8228 GREEN LAKE Dr N, SEATTLE

A Proposed Apartment Development Project for Goodman Real Estate Inc.

DRD RECOMMENDATION MEETING

PROJECT# 3019810

4. b COVERED PARKING EAST CONDITION

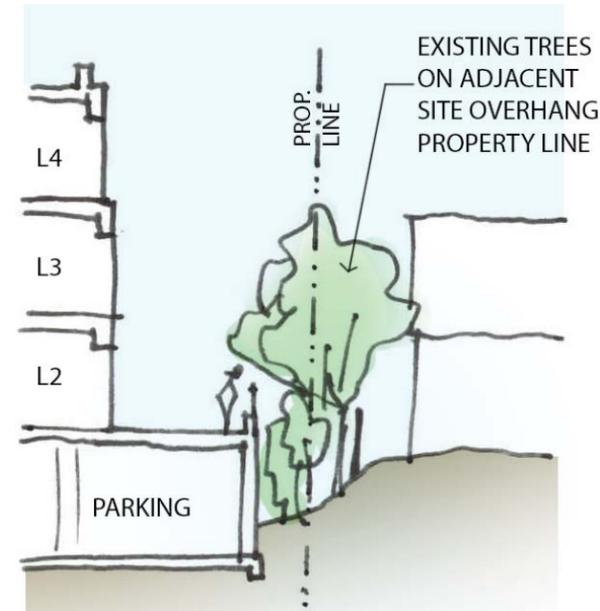
- b. Demonstrate how the visual impacts of the open parking will be minimized. The Board was concerned about a potential blank wall condition along. (CS2-B, DC1-C, DC2-B)

As demonstrated in eye-level renderings, the parking is completely screened from view from all vantage points. The blank wall facing south continues the pattern of verticality of the commercial frontage to connect with Green Lake Dr N.

4. NORTH FACADE A

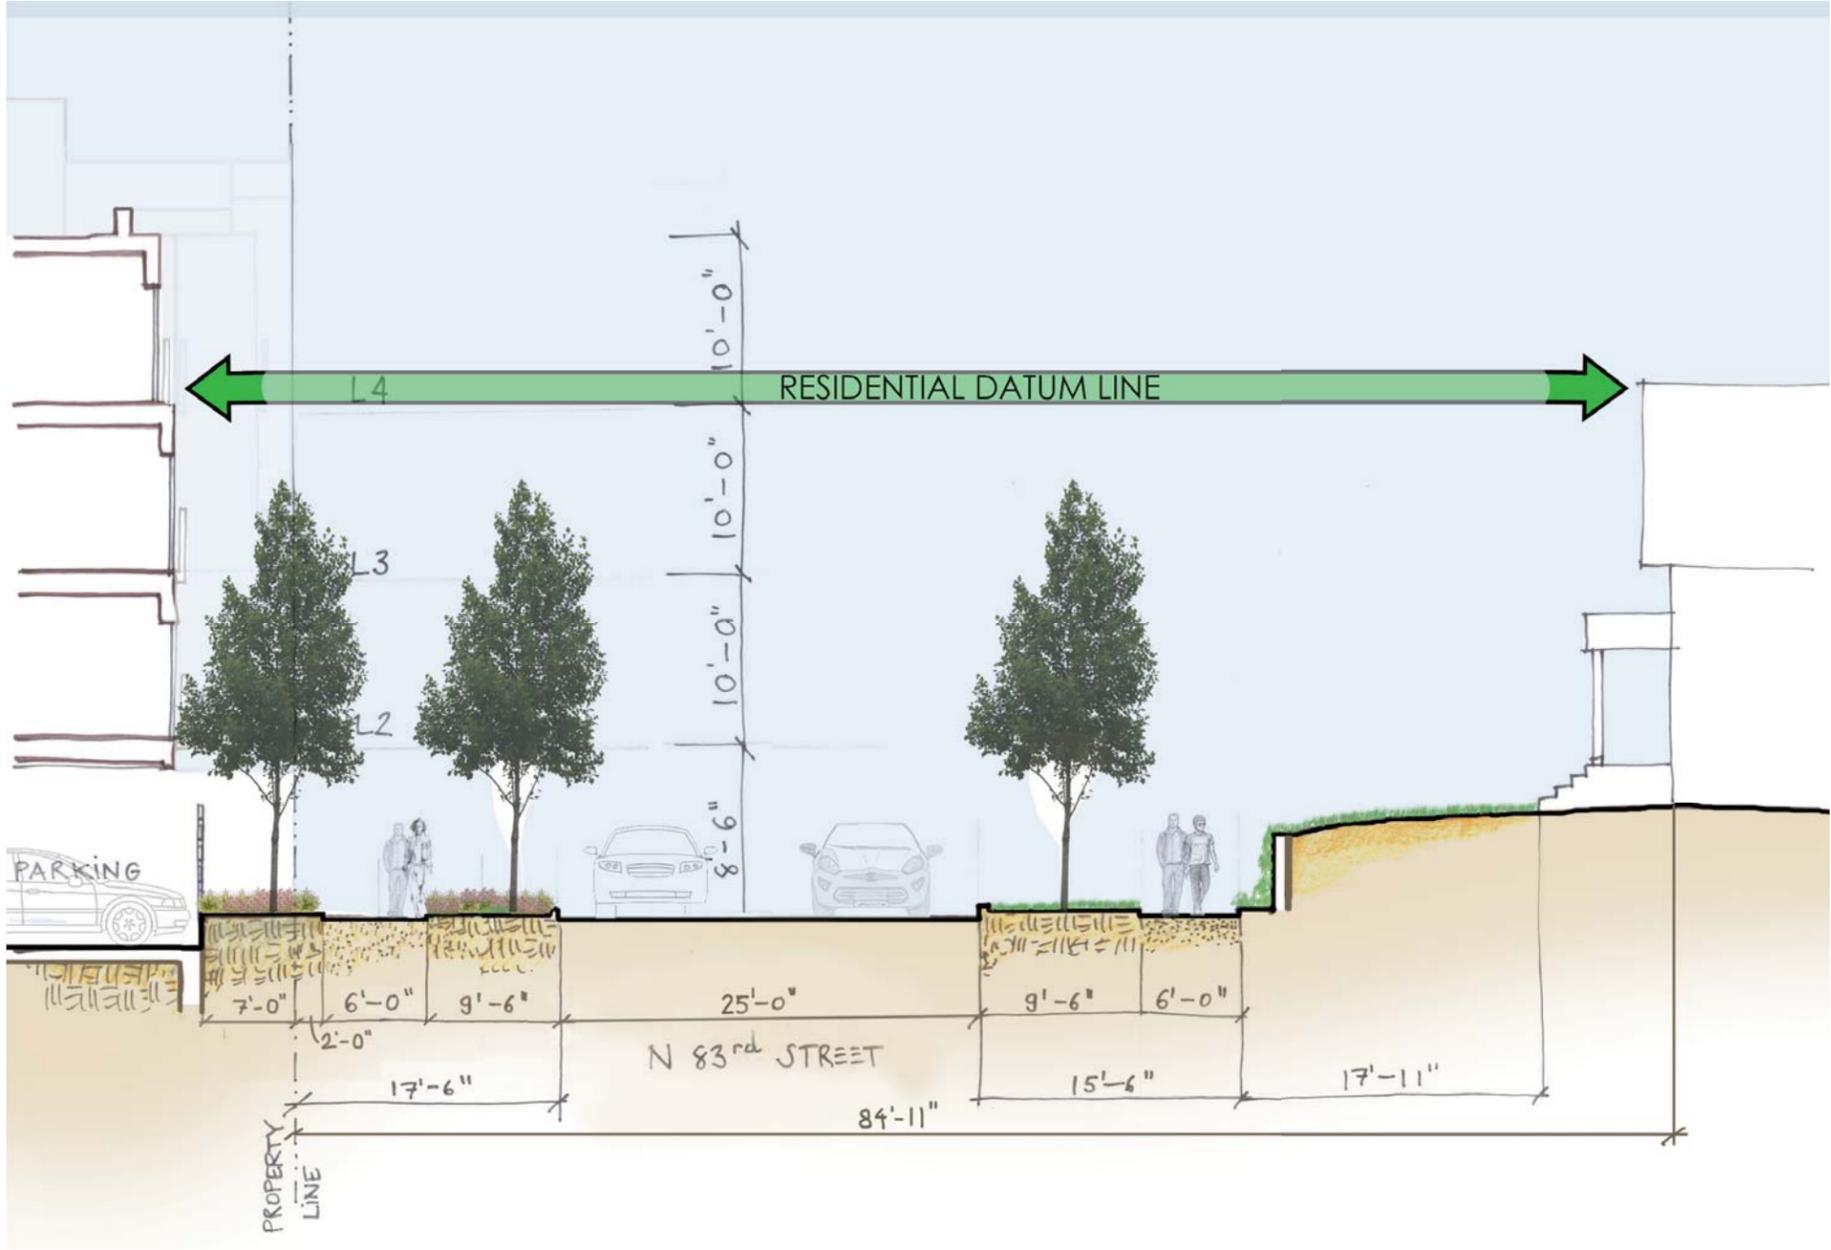
- b. The concept of the setback of the upper level was supported by the Board as a strategy to reduce the perceived height of the building. However, the plane shift of the upper level set back is minimal. The Board encouraged the applicant to explore setting back the upper floor further, and/or bringing out the lower floors slightly to increase the distance of the setback. (CS1-B, CS2-B, CS2-D, CS2-II)

- c. The differentiated expression at the upper story helps to reduce the perceived height and bulk of the building, and the Board encouraged the applicant to explore design strategies that further achieve this objective. (CS1-B, CS2-B, CS2-D, CS2-II)

A Upper level setback increased provide greater visual relief to facade. B Vertical bays modified to create unified rhythm with 3' balconies adding depth. C Material and color transition reduces bulk and scale. D Residentially sized and detailed fenestration openings relate to the scale of the neighborhood. E Landscaping and fencing carefully detailed to create pleasant pedestrian experience.

RESIDENTIAL - CONCEPTUAL SECTIONS

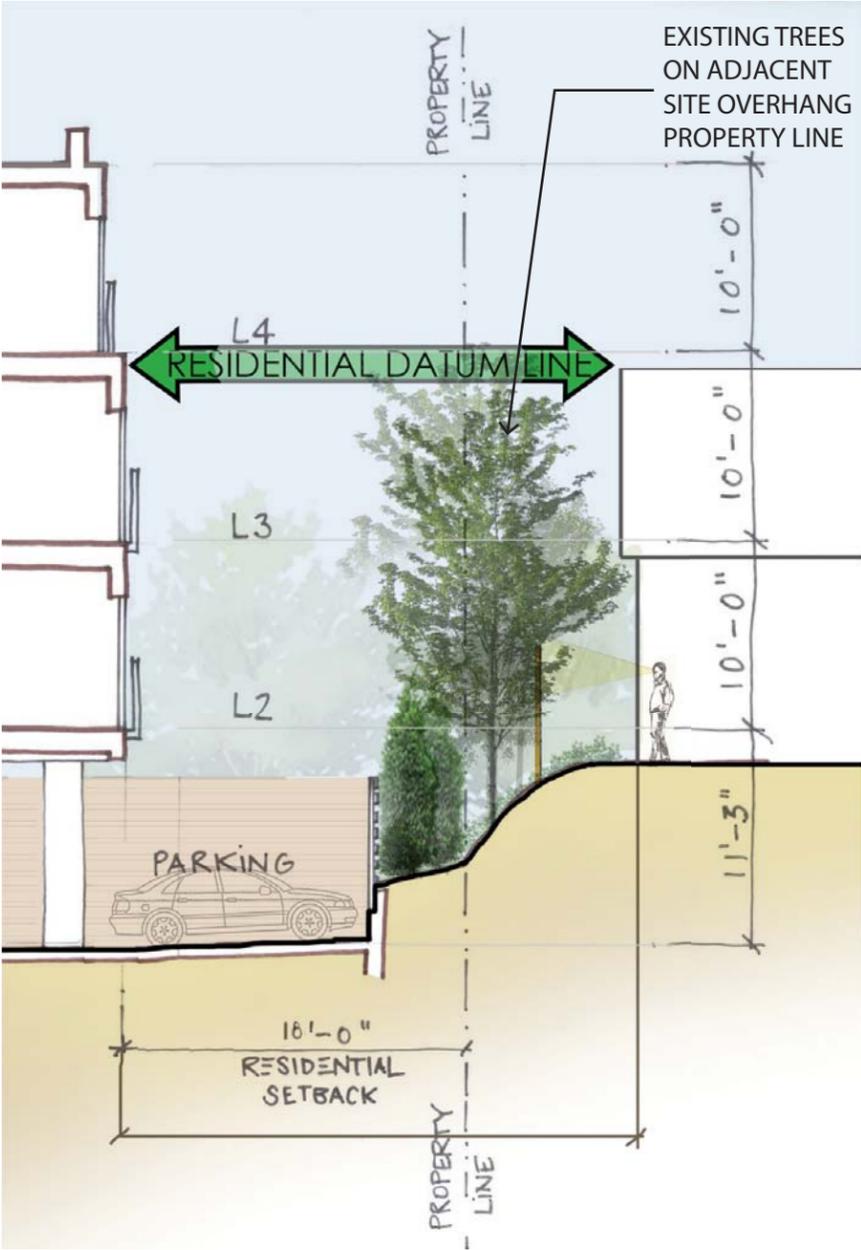
- a. Consider how to use the conditions created by the topography and parking location as an opportunity for a successful transition. The Board encouraged the applicant to explore lidding the parking to provide a greater buffer or amenity space, or creating a podium at the ground level. (DC2-A, DC4-A, DC4-D)

The proposed below-grade parking design provides the least intrusive transition to the east single-family neighbors. A section provided demonstrates the minimal advantages of lidding the parking for the building do not outweigh the negative privacy and noise impacts to the neighboring property.

REVAMP PANEL SECTION AT WINDOW

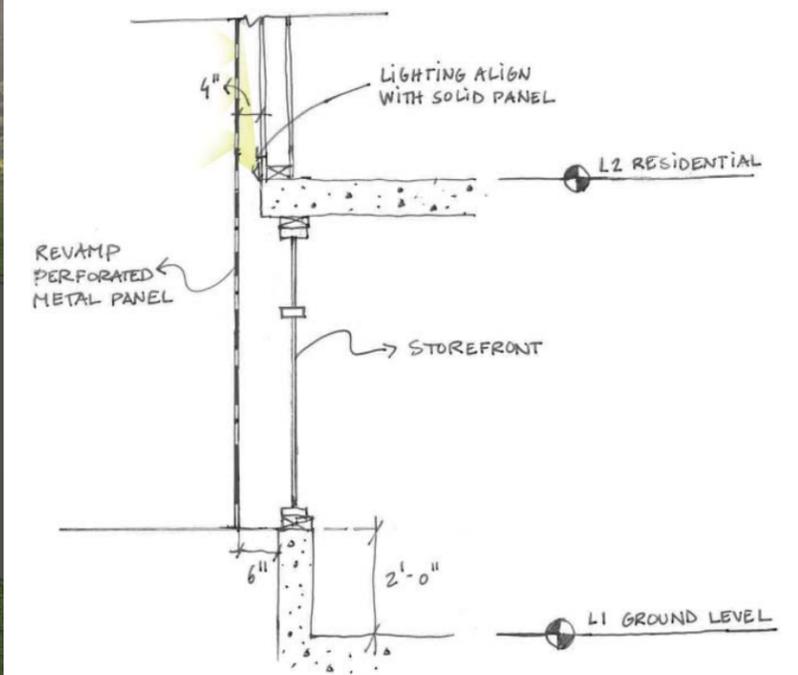
- c. The Board requested more information regarding the materials and detailing of the upper three levels, including how these levels interact with the ground level. (DC2-A, DC2-B)

The metal skin is comprised of 3/16" thick panels custom-cut to provide the silhouette of trees. These dark metal panels are 4" proud of the light building envelope to produce a visual effect of looking through trees, similar to an experience found throughout Green Lake.

DEPARTURE REQUEST

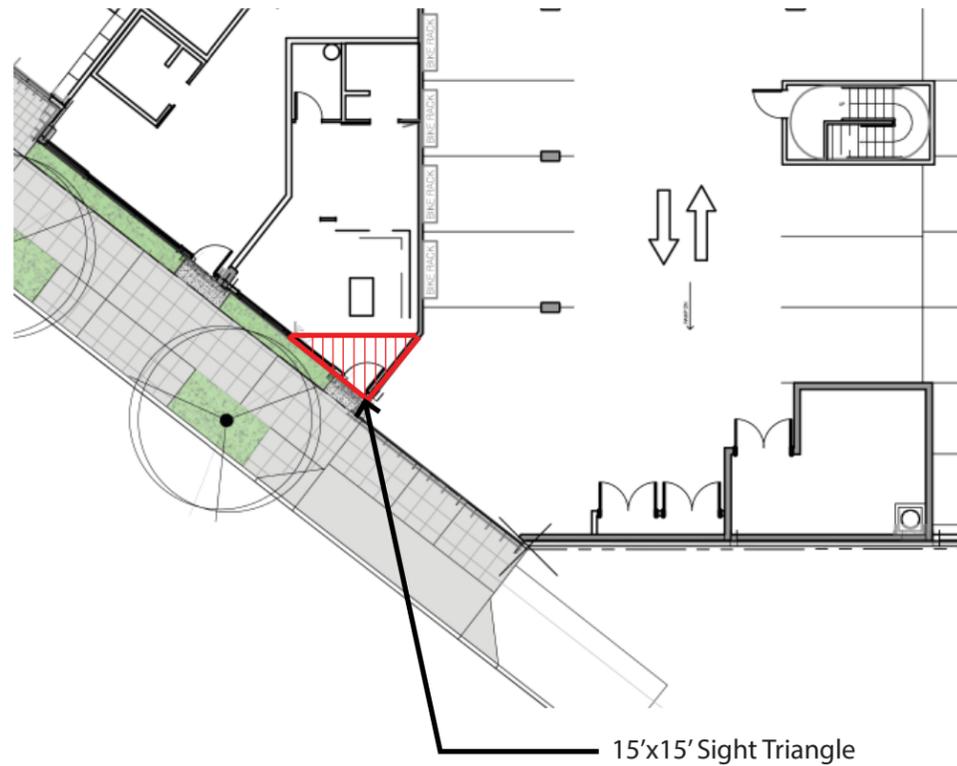
DEPARTURE REQUEST:

Allow alternative measures to meet requirements: convex mirrors and signal lights

Guideline A-8, C-1, C-5: Use of convex mirrors and signal lights, as regularly approved by DPD for use in urban sites, will provide a similar standard of pedestrian safety while at the same time minimizing the visual impact of the parking garage entry and maintaining continuity of commercial facade.
